Technical change to: Screwdriver-tip slot

- PCN-PW63xxxx-20210503-00-A EN
- 03.05.2021

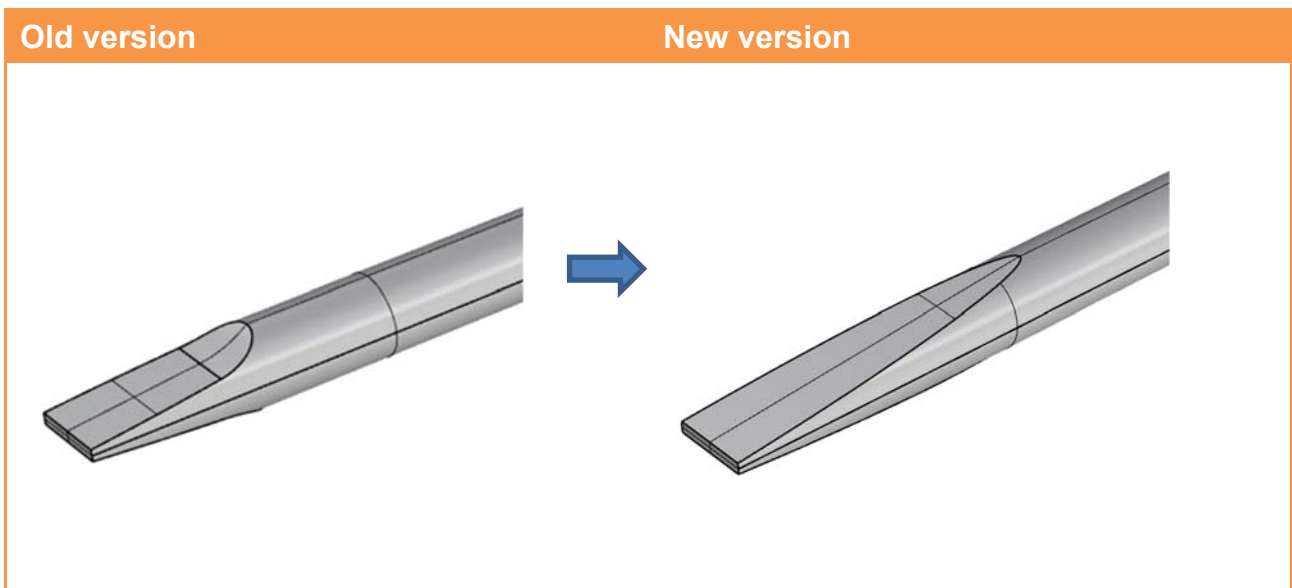
Adjustment of the blade tip to a straight run-out.

The previous screwdriver blades were sanded. This automatically resulted in a straight runout of the blade tip. The new screwdrivers are milled, so the runout is different. Both correspond to the standard. However, it leads to the fact that the angle for actuating our tension clamps terminals (Z-line) is too large and no longer works.

We have now found a solution so that the blade tip also has a straight run-out of the blade tip during the milling manufacturing process, like the previous screwdrivers, and works without any problems with all of our tension clamp terminals.
